APPLICATION NO.	FILING DATE	FIRST NAMED INVENTOR	ATTORNEY DOCKET NO.	CONFIRMATION NO.
09/780,814	02/09/2001	Patrick Barrow	13DV13726	8662

Office Action Summary

Title: Methods and Apparatus for Electronically Modeling Aircraft Engine Harnesses

FIG. 7

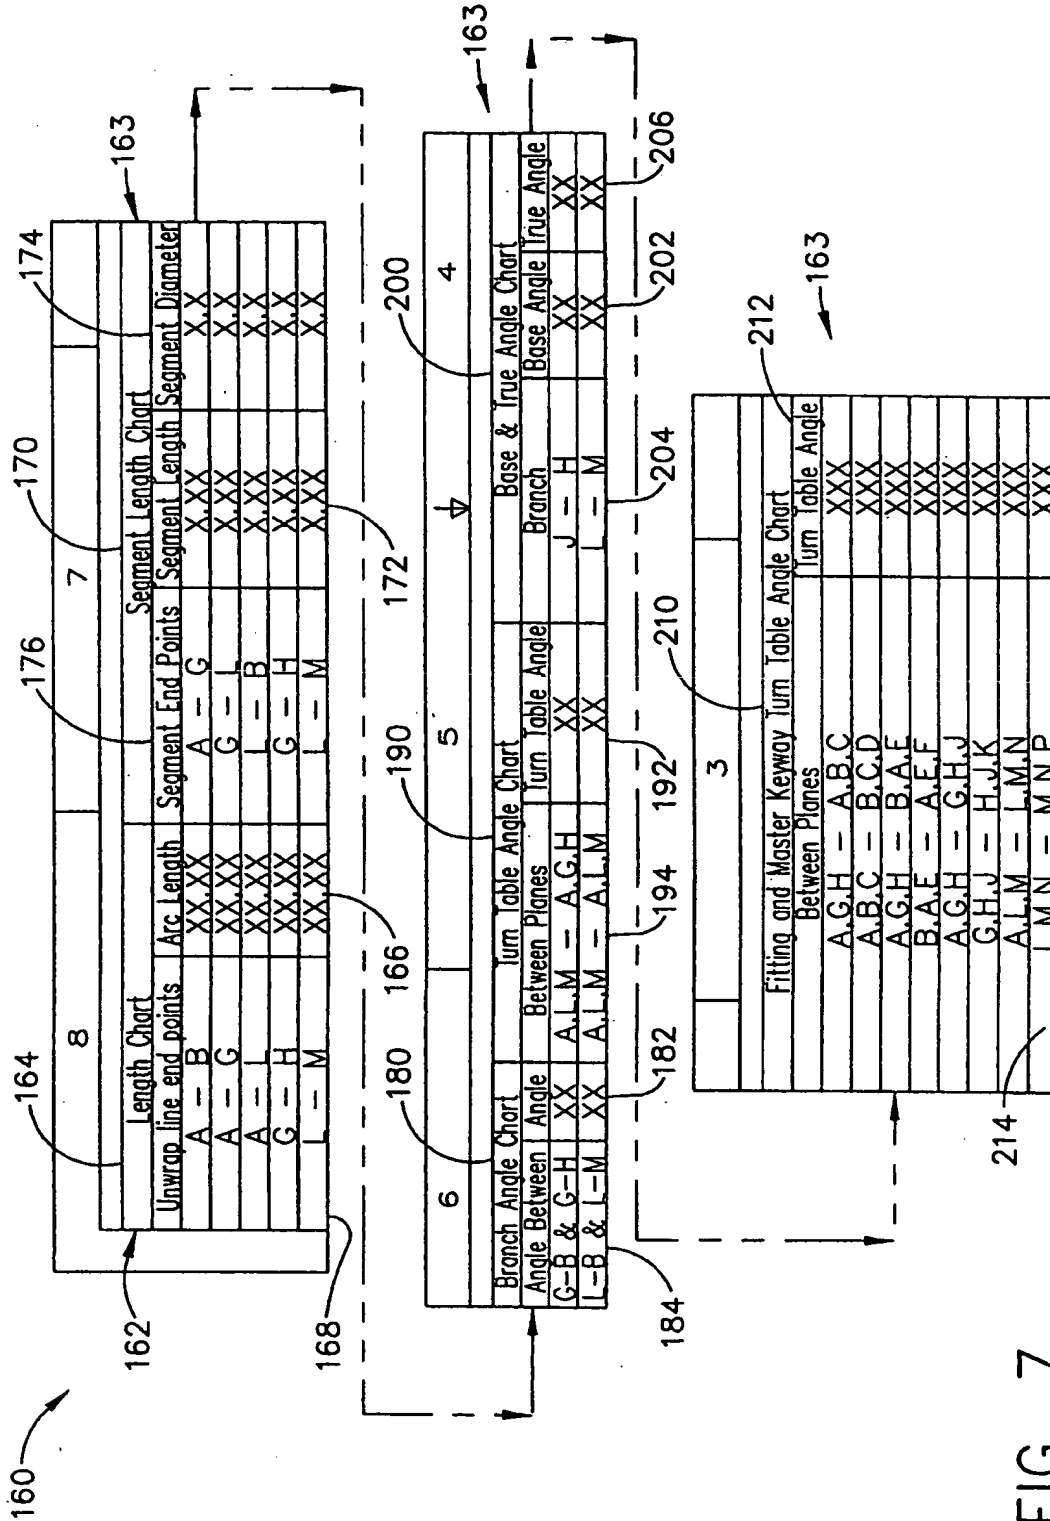
2. The proposed drawing corrections to FIG. 7 and the replacement sheet of FIG. 7 received on February 10, 2005, are acceptable. The objection to the drawings has been withdrawn.

*OK to enter.
H.D. 6/10/05*
